Re: Response to Comments on Updated Groundwater
Modeling Report
Claremont Polychemical Superfund Site
SAIC Project 01-1633-04-5386-552

UPDATED GROUNDWATER MODELING REPORT FOR THE CLAREMONT POLYCHEMICAL SUPERFUND SITE

OLD BETHPAGE, NEW YORK

February 2011

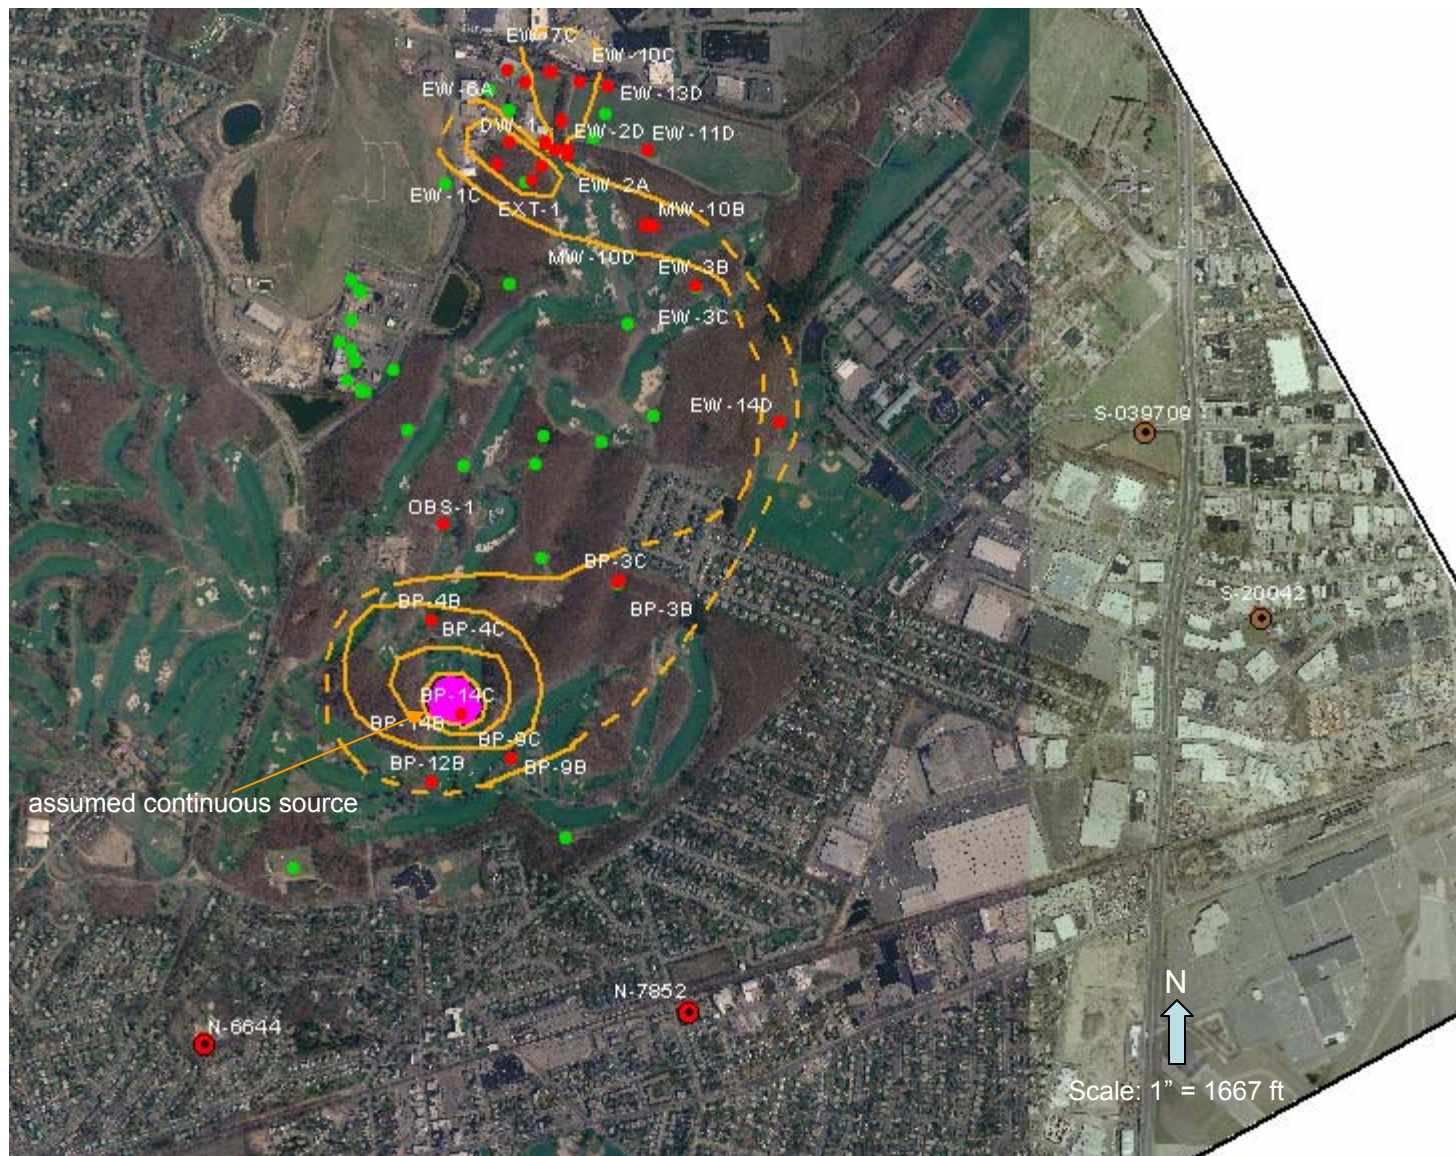
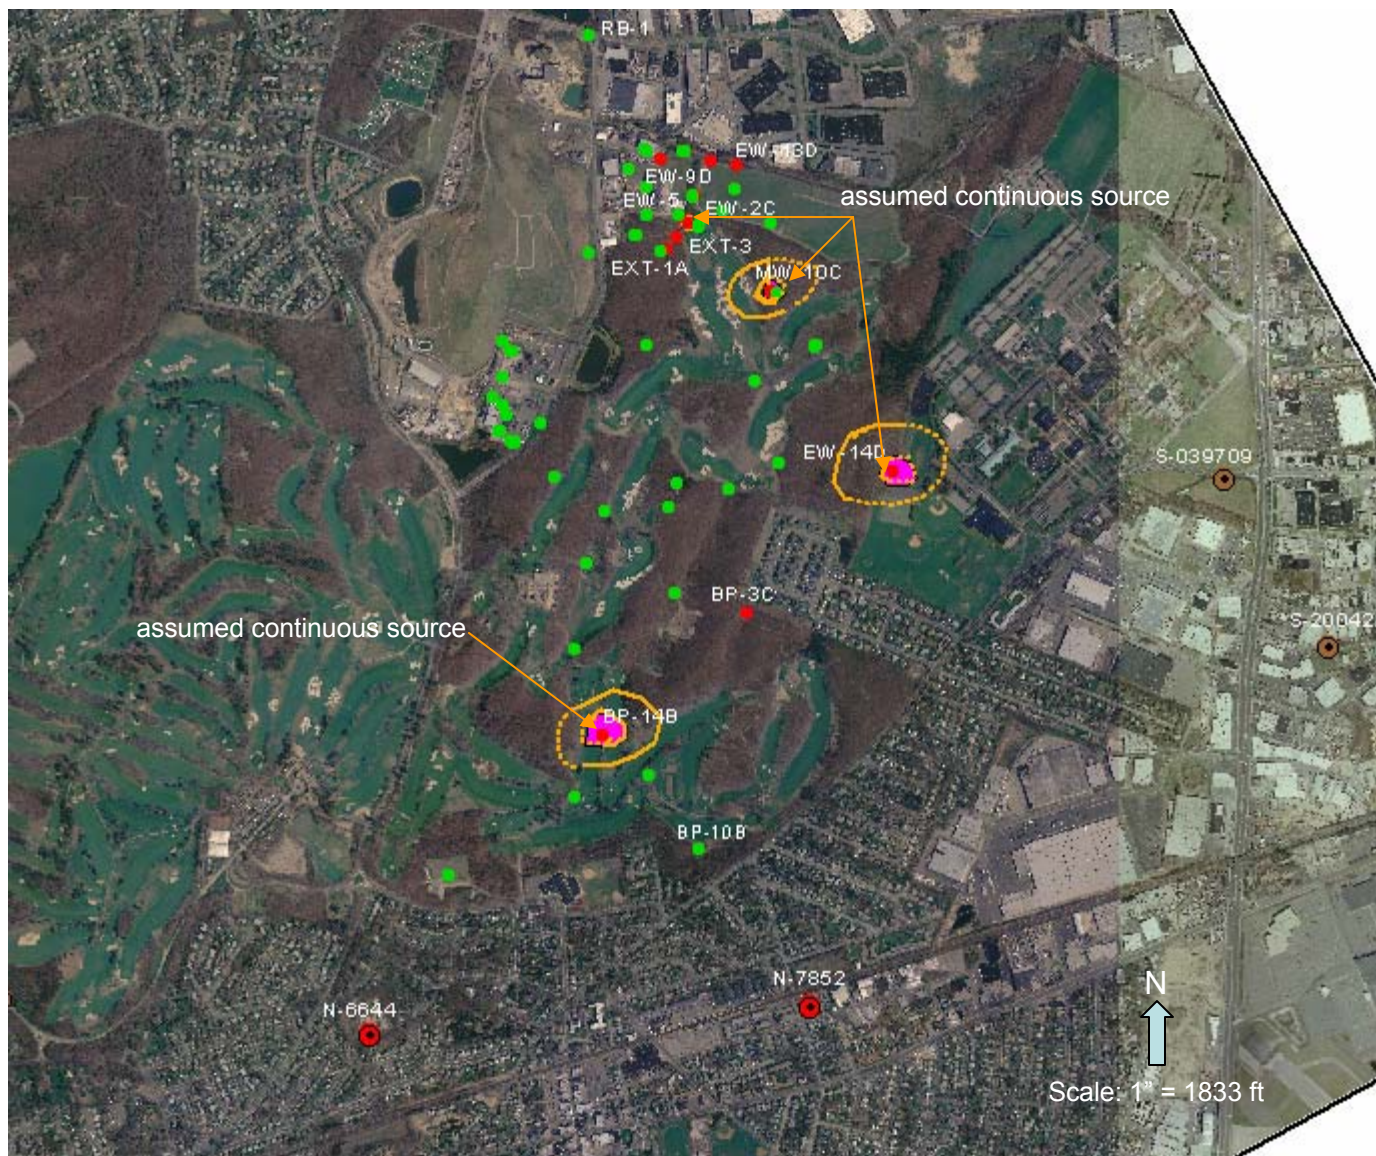
5. *Page 9, last ¶; figures 3-1 to 3-3; tables 3-1 to 3-3*: It is recommended that the vertical stratification of plumes be considered when characterizing plume distribution in the aquifer. The tables containing TCE, PCE, and 1,1-DCE data should list the screening intervals for wells in which detections were reported. Additional plots can be made that show concentrations relative to model layers or to horizontal planes representing highest intersection of well screens. Select cross sections could also be useful to help envision plume distribution with depth.

Concur in part. The screened intervals for all wells have been inserted in Tables 3-1, 3-2, and 3-3. There are an insufficient number of data points within any one layer of the aquifer to develop a plume map for an individual aquifer layer. Since there is insufficient data to support development of per layer plume maps, cross-sections have been developed to illustrate concentrations at various depths along one transect through the axis of the northern end of the plume (well EW-7D to well EW-14-D), one transect perpendicular to the axis of the northern end of the plume (well EW-8D to well EW-13D), one transect along the axis of the southern end of the plume (well EW-14D to well BP-12A,B,C), and one transect perpendicular to the axis of the southern end of the plume (well OBS-1 to BP-10,B,C).

Figure 3-2. TCE Plume Map
Contours 5, 50, 100, 500, and 1000 mg/L

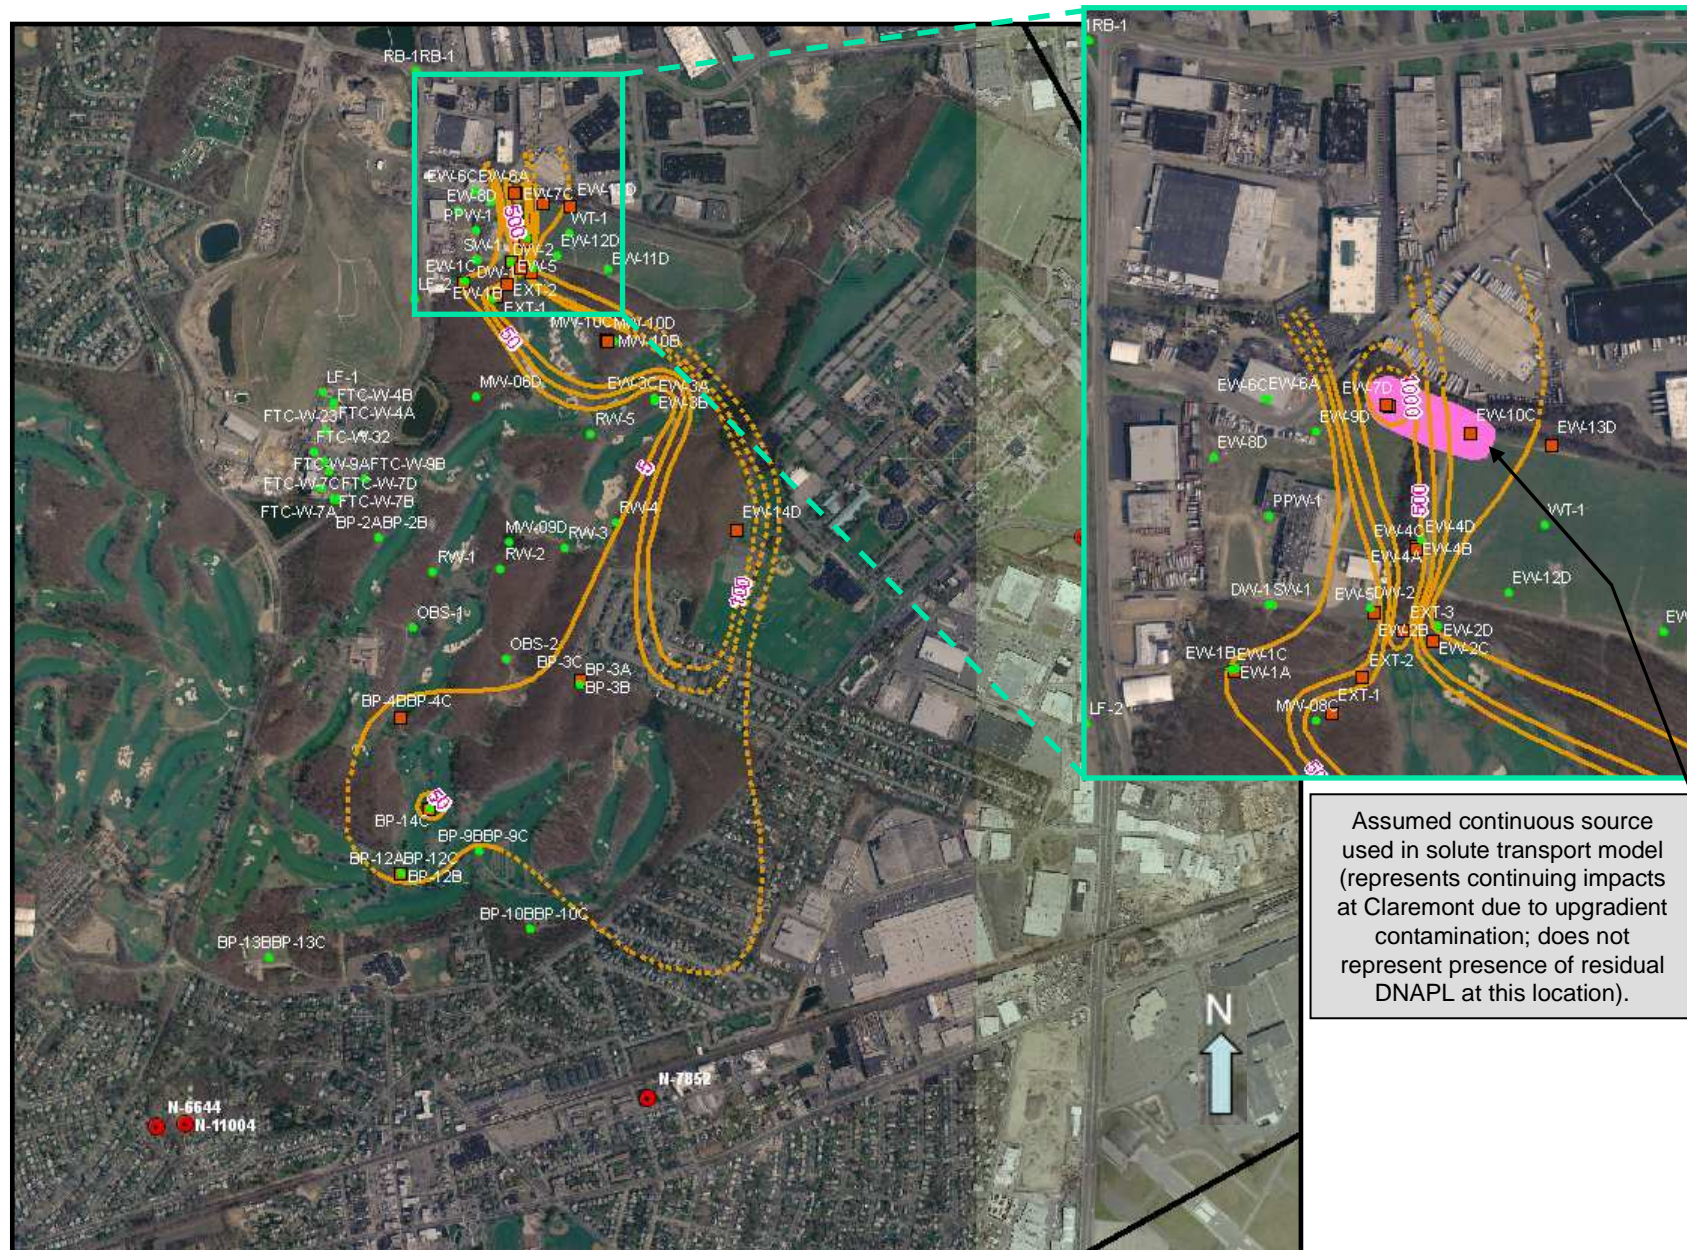
4a. *Page 9, 3rd ¶ under 3.1 Conceptual Solute Transport Model; figure 3-2*: a. The paragraph indicates that there is a possibility of an up-gradient contribution to the groundwater TCE plume thought previously to originate entirely from the Claremont site. However, it is not clear what evidence there is for this supposition. Figure 3-2 shows the 5 ppb iso-concentration line for the TCE plume as solid along the northern extent of the site. This representation indicates that the plume's extent is constrained by data points north of the plume. If this is the case, then there appears to be no contaminated groundwater in the area immediately up-gradient of the site. Please discuss further what the evidence is for an up-gradient contribution to TCE contamination.

4b. The paragraph states that the area near wells EW-7C/EW10C is considered to represent a continuing source of TCE. The highest TCE concentration reported for well EW10C is 1,400 µg/L. Note, however, that according to OSWER publication 9355.4-07FS (Estimating Potential for Occurrence of DNAPL at Superfund Sites) concentrations of DNAPL related chemicals in groundwater that are greater than 1% of pure-phase or effective solubility, indicate proximity to source. For TCE a concentration of 11,000 ppb would indicate a potential source in the aquifer.

Concur. Text has been edited to indicate that additional ongoing investigations corroborate the existence of an upgradient source (in addition to the existing statement that the highest TCE concentrations are detected near monitoring wells EW-7C and EW-10C, which are located at the upgradient and eastern side of the Claremont site). The iso-concentration lines on the TCE plume map (Figure 3-2) have been changed from solid lines which close north of the Claremont property to dashed lines projecting an open, undefined extent of groundwater contamination north of the site.

Concur in part: It was assumed in the model that in the area of wells EW-7C/EW-10C, there is a constant flux of TCE from a source up-gradient of the site resulting in a steady state concentration in this area. Therefore, the EW-7C/EW-10C area was assumed to be constantly receiving TCE from an up-gradient source, causing this area to act as a constant source for the further down-gradient portions of the plume.
Statement in question (i.e., "For modeling purposes, this area is considered to represent a continuing source of TCE.") has been eliminated from Section 3.1 (as Section 3.1 is conceptual model and not numerical model discussion). This issue has been clarified in appropriate location in Section 3.2.3.2.

Figure 3-6. Starting Locations for Particles Discharging to Selected Wells
Suffolk County S-20042 and S-39709; Village of Farmingdale N-7852; Claremont EXT-1, EXT-2, and EXT-3;
TOB recovery wells RW-1 through RW-5; & NCDPW extraction wells RW-1 and ORW-4 through ORW-7

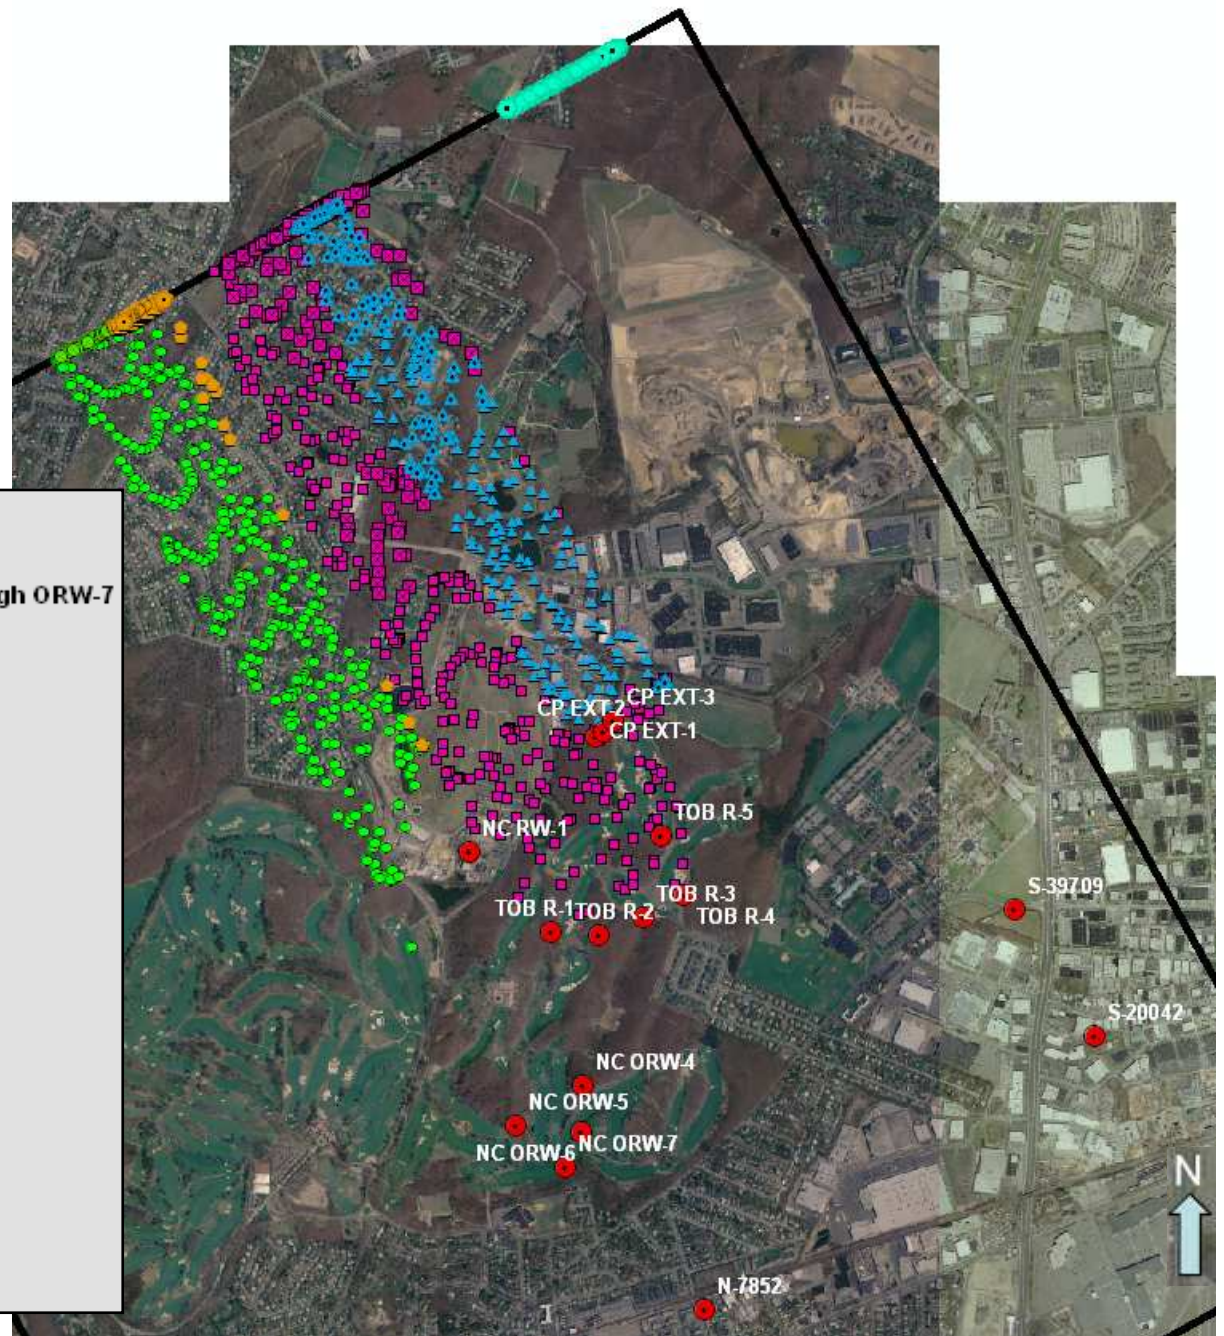
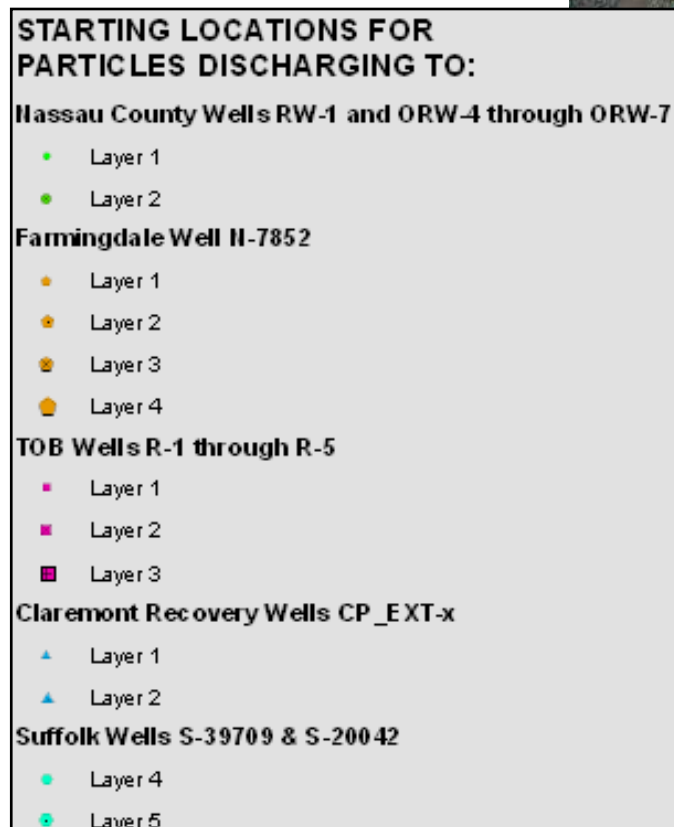
8. *Page 14, ¶beginning with "Particle tracking analysis..."*: It is not apparent what the capture zone analysis intends to demonstrate. In the analysis described in the report, a line of particles is located along a model row just down-gradient of the Claremont site, presumably to determine capture zone width for various supply wells located down-gradient of the site. Because the particles describe a limited recharge area (a model row), a full mapping of recharge locations to discharge locations (wells) is not realized. Consider performing an analysis that maps the full recharge areas to wells. Consider also mapping capture areas in sections perpendicular to flow that coincide with plume boundaries to wells. The particle tracking software used in this analysis (Modpath) allows for such an analysis (referred to as an end-point analysis).

Concur. A capture zone analysis (using endpoint analysis as appropriate) has been preformed for Claremont, TOB, and FTC recovery wells, and selected municipal water supply wells within the model domain. The results of the capture zone analysis are illustrated on Figure 3-6.

Figure 3-7. Backward Particle Tracking from
Village of Farmingdale Municipal Supply Wells (N-7515, N-7516, N-7852) (wells in Zone C-Upper)
and Suffolk County Water Supply Wells (S-39709 and S-20042) (wells in Zone C-Lower)

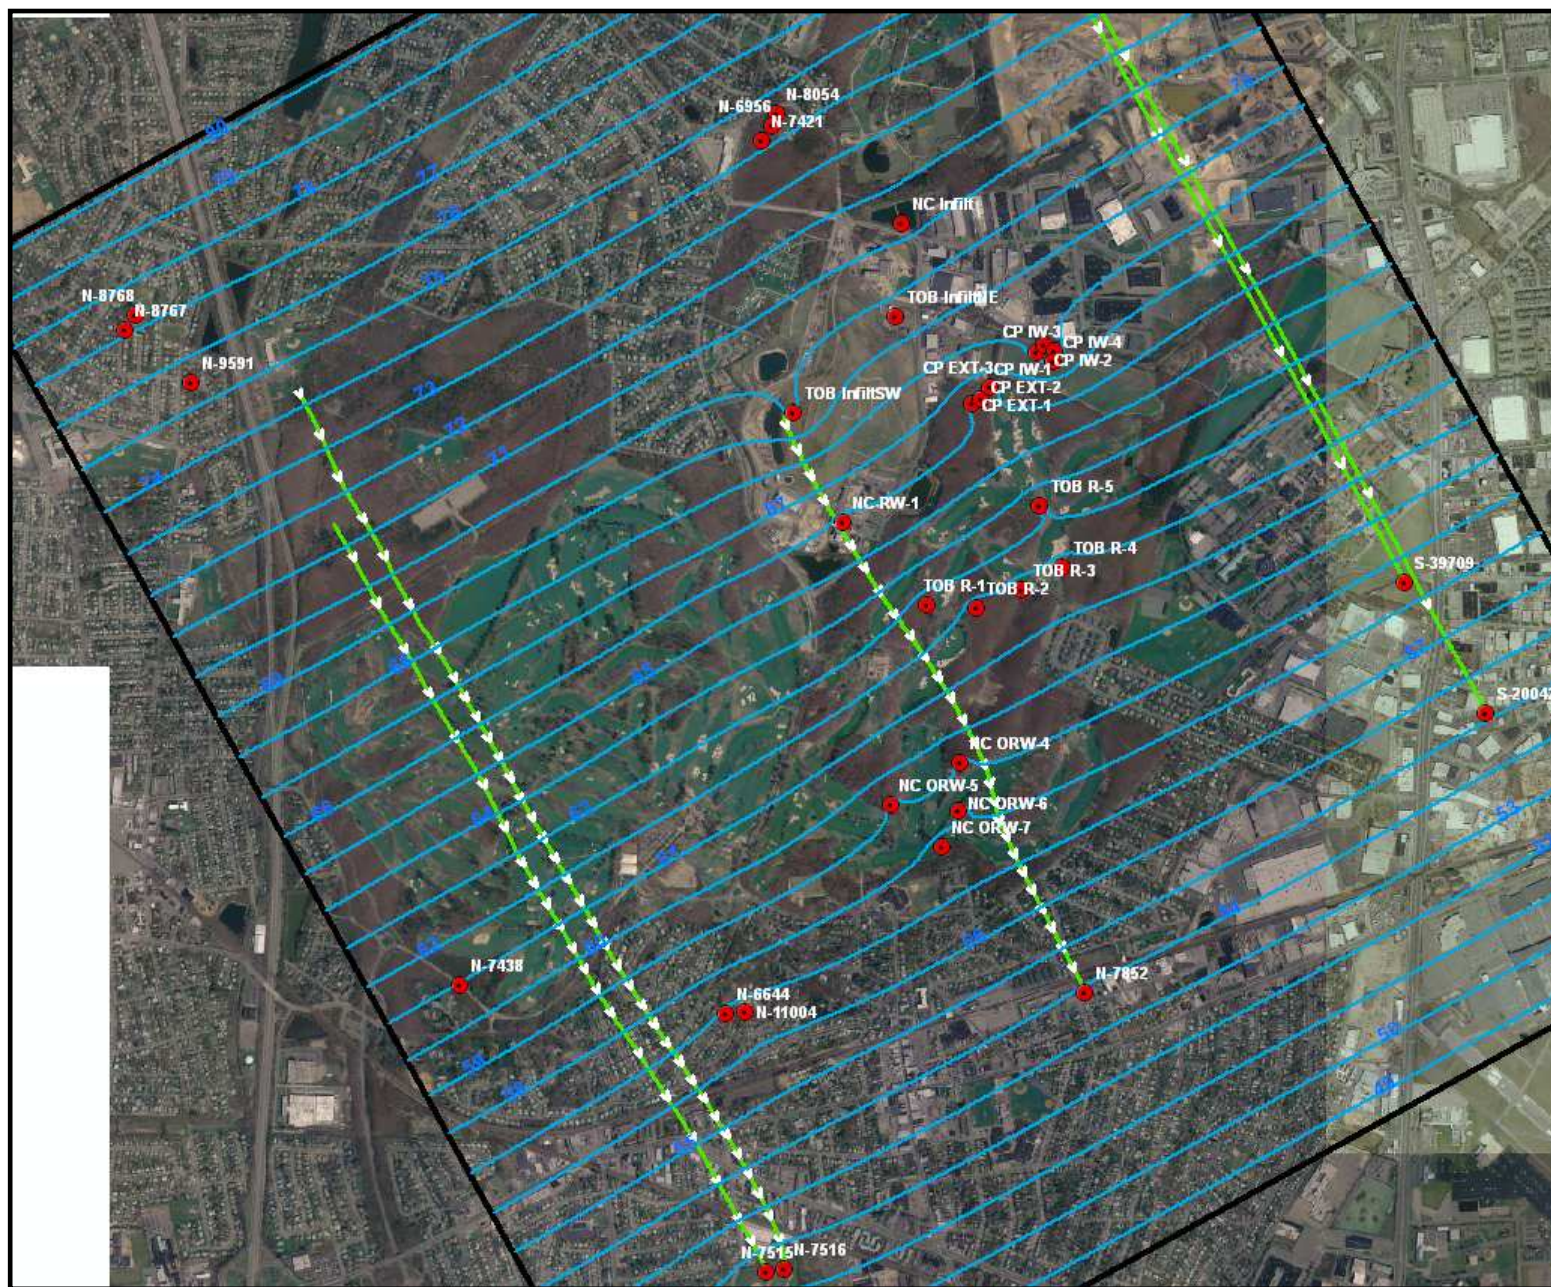
6. Figures 3-7a and 3-7b. Please change the backward particle track color to green to be consistent with Figure 3-4.

Concur. The color of the backward particle track color has been changed from red to green to be consistent with Figure 3-4.
